**Motion: To adopt the staff report as findings of fact, to approve the site plan, and to recommend to the Township Board to grant tentative preliminary plat approval of the layout of the Preliminary Plat of Bauer Ridge, P.P. # 70-14-08-400-025, located at 3358 Bauer Rd., Georgetown Township, Ottawa County, Michigan, as shown on the drawing dated February 09, 2016, and**

ID number		Date	2/10/2016
Name	Bauer Ridge		
Address			
Use	Preliminary Plat	SUP required	NA

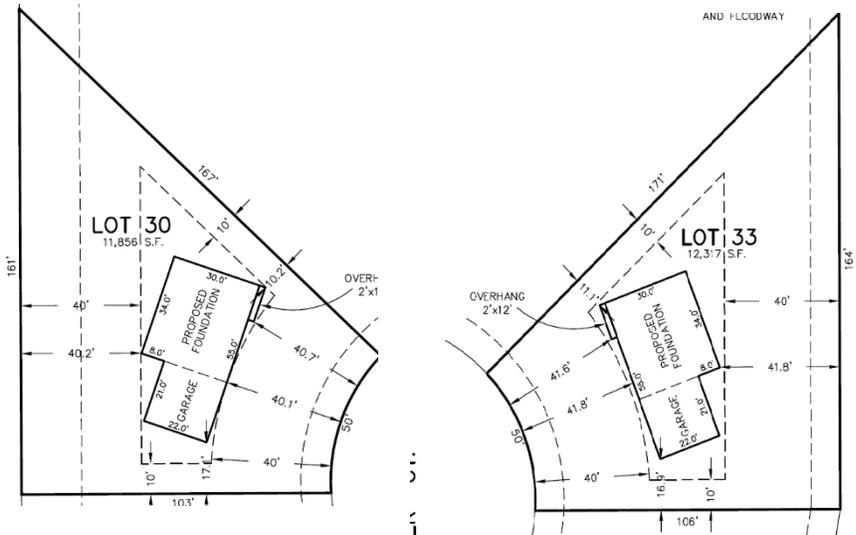
- 2) Lots 1 and 20 are required to have front yard setbacks on Bauer Rd. Therefore, the front yard setback for lots 1 and 20 is 100 feet (40 feet measured from a point 60 feet from the center of Bauer Rd.). **The developer provided a revised sketch that shows the building envelopes to comply with the required setback.**

- 2) Lots 1 and 20 are required to have front yard setbacks on Bauer Rd. Therefore, the front yard setback for lots 1 and 20 is 100 feet (40 feet measured from a point 60 feet from the center of Bauer Rd.), as shown on the additional sketch provided by the applicant.

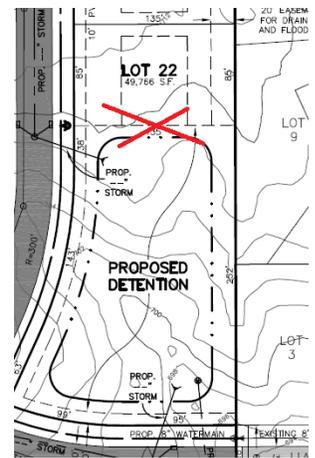
3) Lots 30 and 33 have very small building envelopes. Examples have been provided that the minimum size house would fit on the lots. These situations are noted to be self-created by the developer and would not, therefore, qualify to meet the standard in the ordinance regarding self-created situations should any time in the future a variance be requested for a larger house to be placed on these lots based on those circumstances.

- 3) Lots 30 and 33 have very small building envelopes. Examples have been provided that the minimum size house would fit on the lots. These situations are noted to be self-created by the developer and would not, therefore, qualify to meet the standard in the ordinance regarding self-created situations should any time in the future a variance be requested for a larger house to be placed on these lots based on those circumstances.

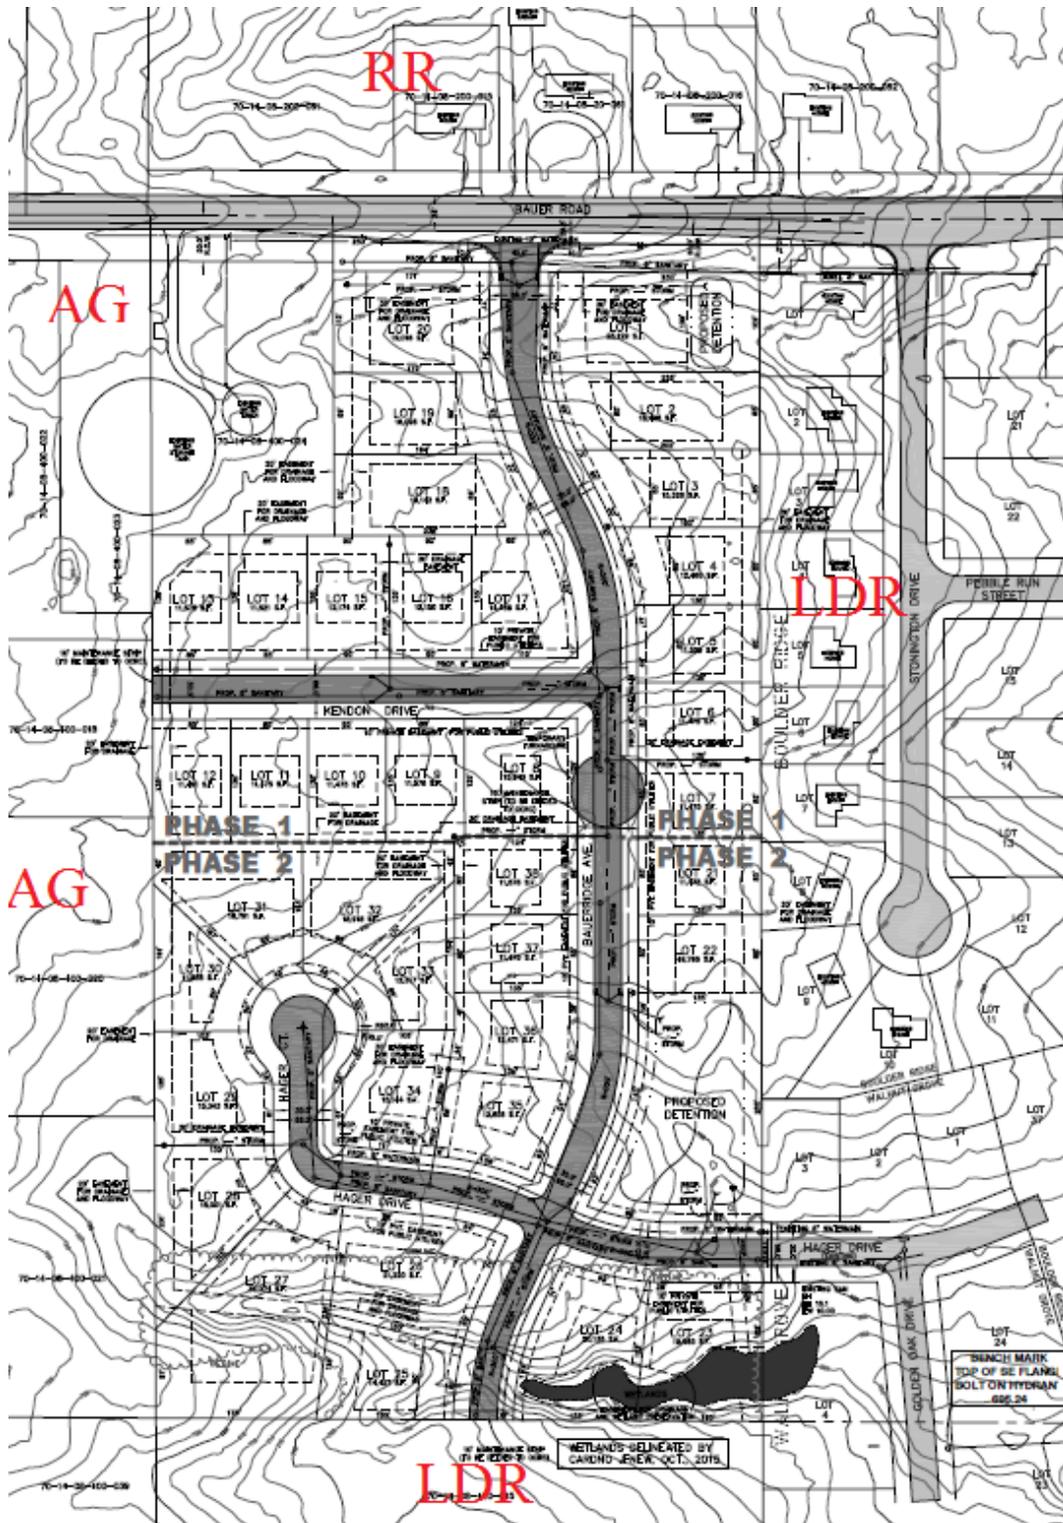
- 3) Lots 1 and 20 shall not have access to Bauer Rd.
- c. As noted on the plan, the developer shall construct sidewalks adjacent to Bauer Rd. and the detention pond on lot 22 at the time the plat is constructed.
- d. The plan fails to show the adjacent zoning. See the map below. Adjacent zoning is as follows:
  - 1) To the north RR
  - 2) To the east and south LDR
  - 3) To the west AG
